City of Portland, Maine - Building or Use Permit Application

Permit No: 01-0240	Issue Date: APR 13 2001	CEL: 197 L001001
-----------------------	----------------------------	---------------------

Project description:
ADDITION TO KITCHEN, LIVINGROOM + BDRM

BUILDING PERMIT REPORT

**SITE PLAN
FOR SETBACK COMPLIANCE
STUART & ABBIE CARTER PROPERTY
95 WESTLAND AVENUE
PORTLAND, MAINE**

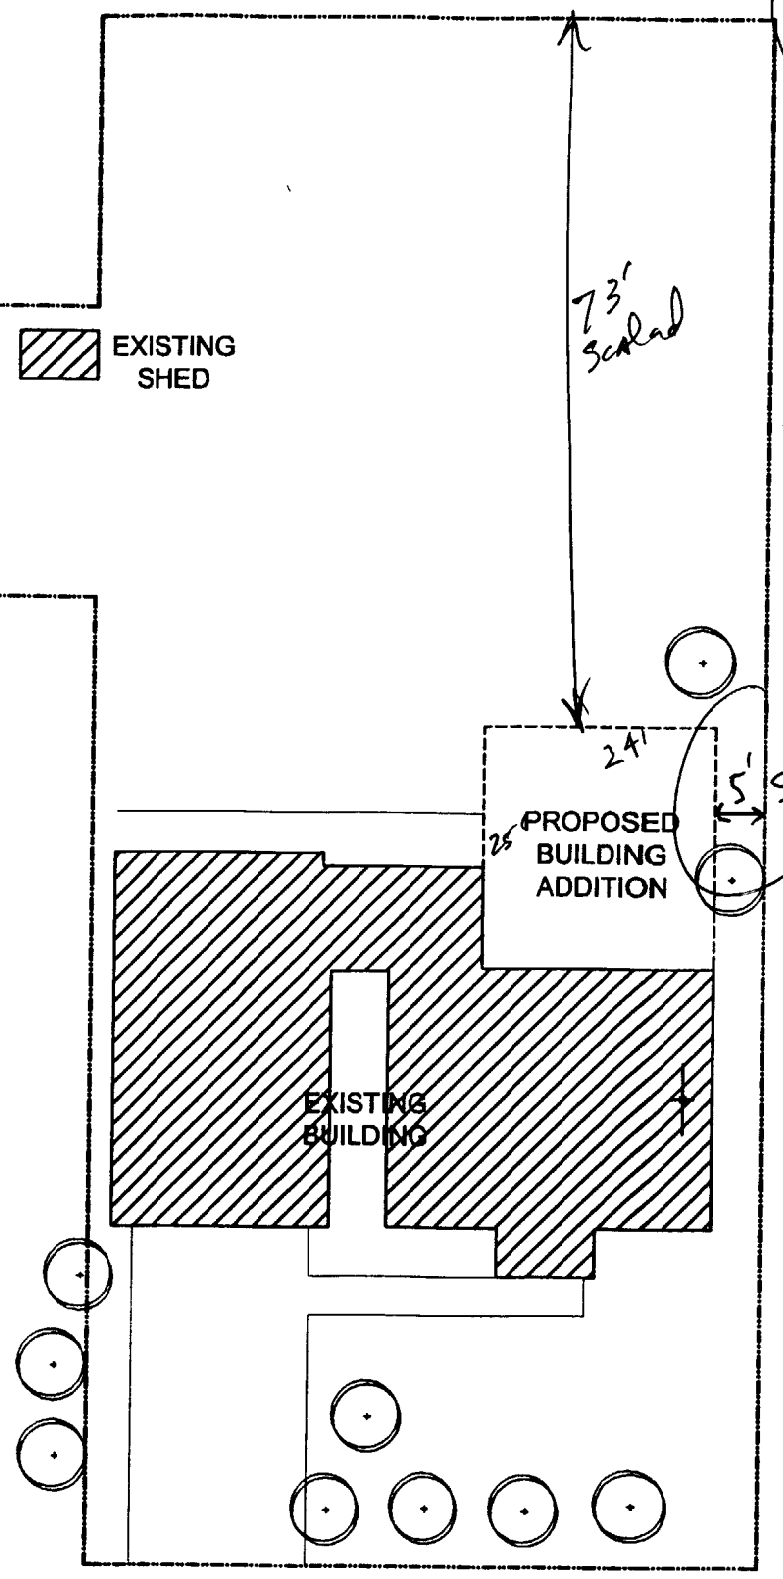
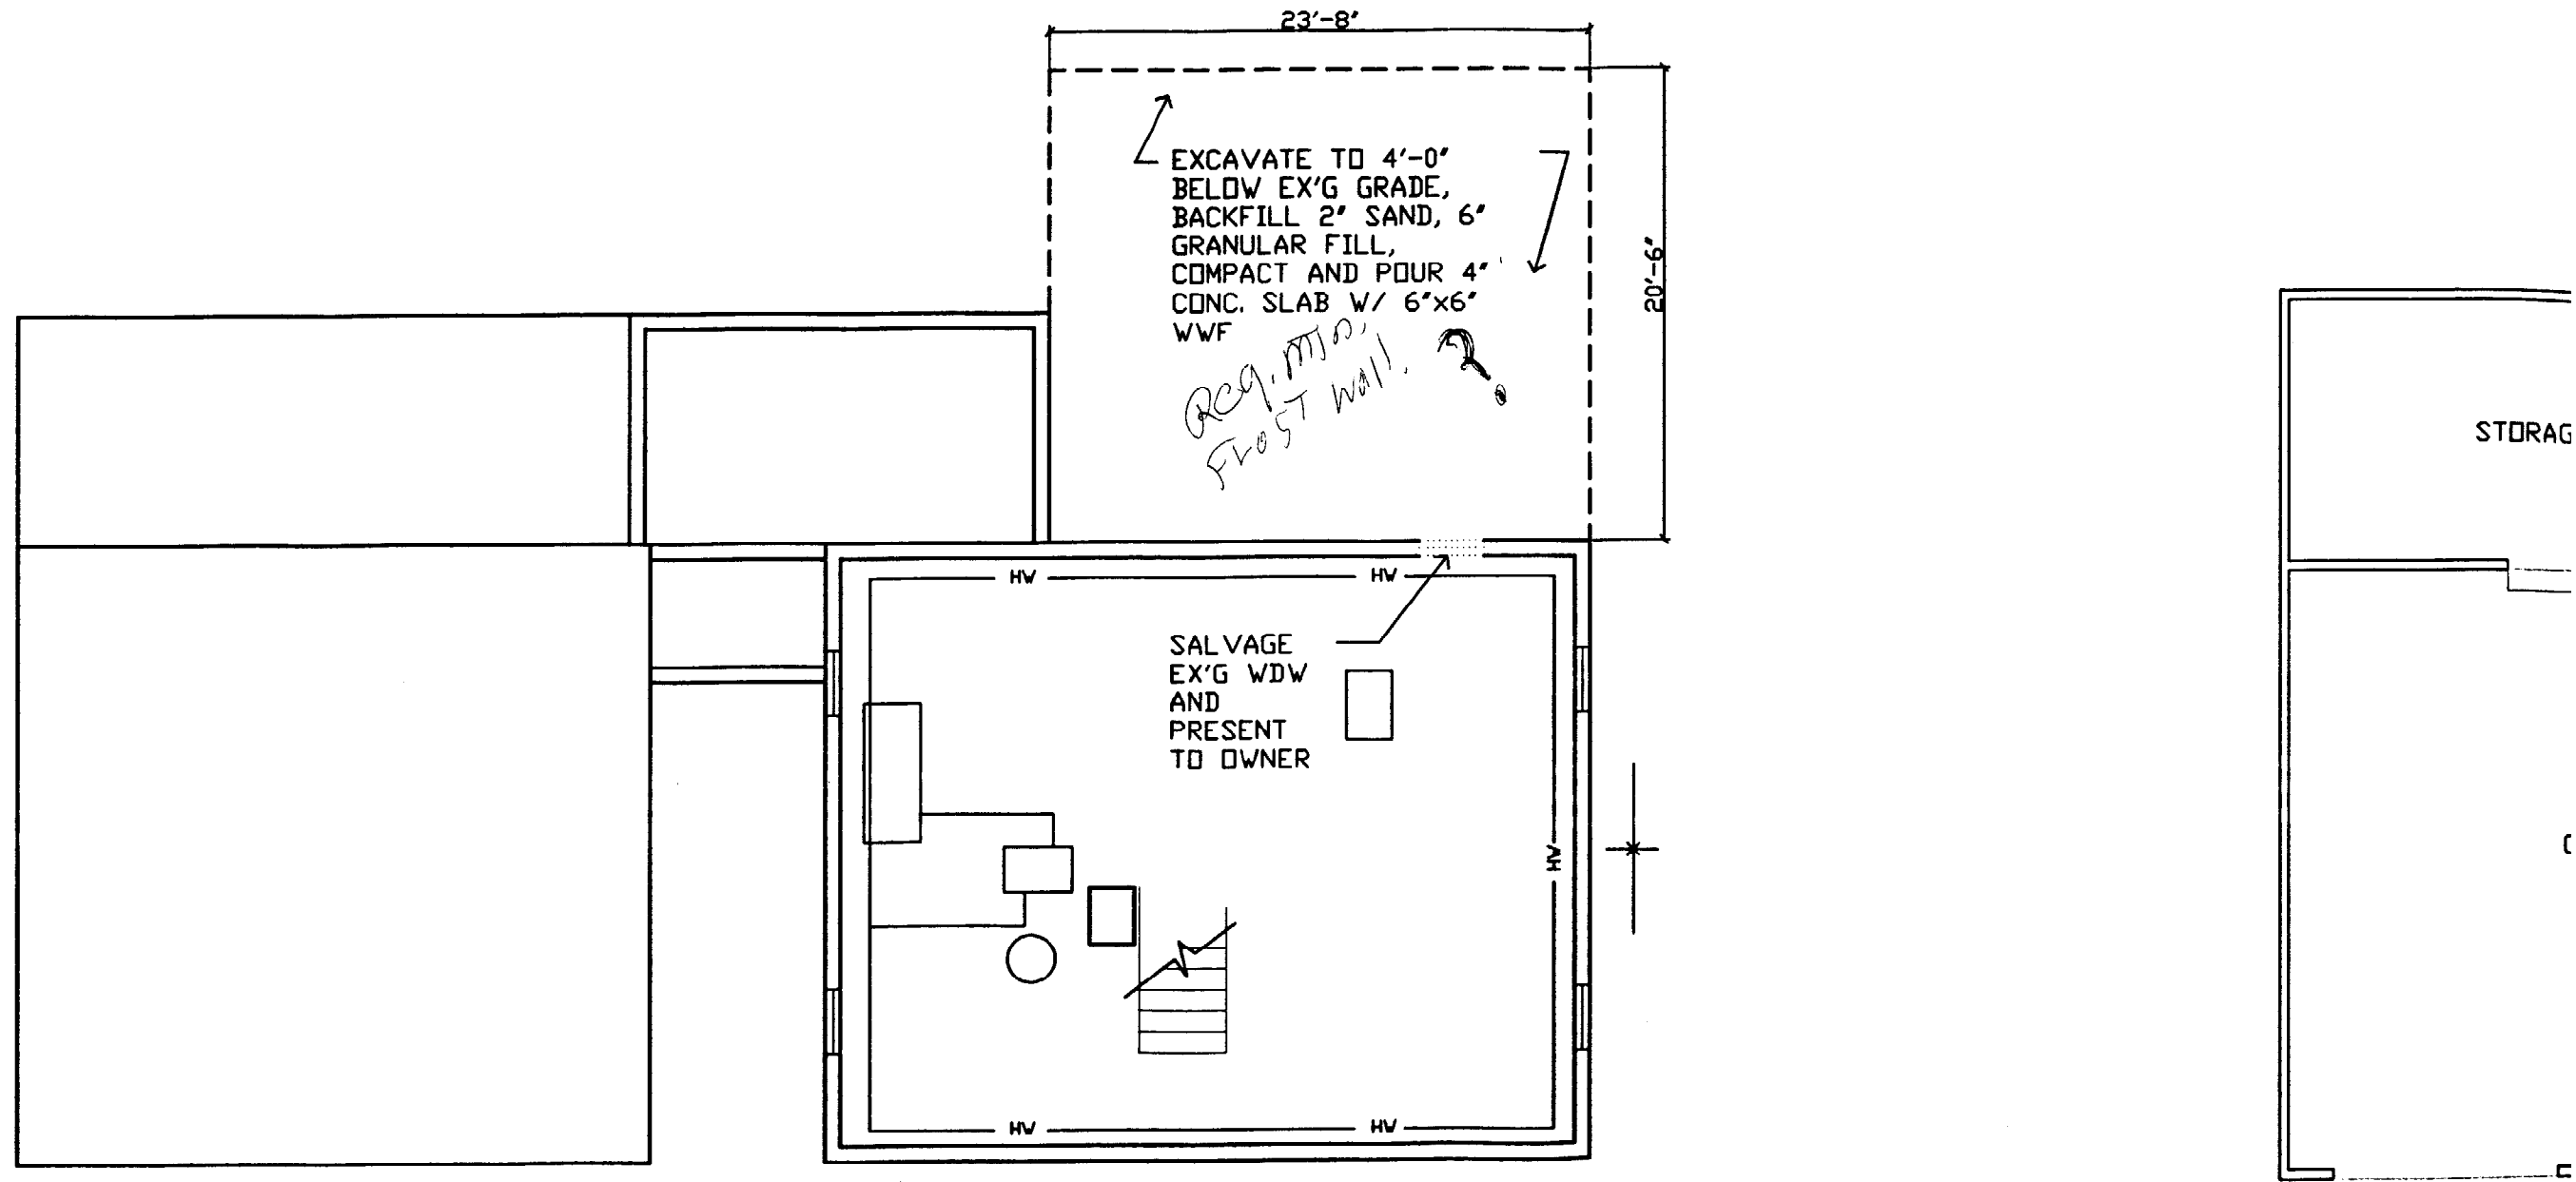
REAR: 20' req - 73' setback
SIDE: 5' min per sec. 14-

shall be NO less than 5' - min

12. Other requirements of condition: The side setback shall be no less than 5 feet exactly (reduction allowed under 14-433)
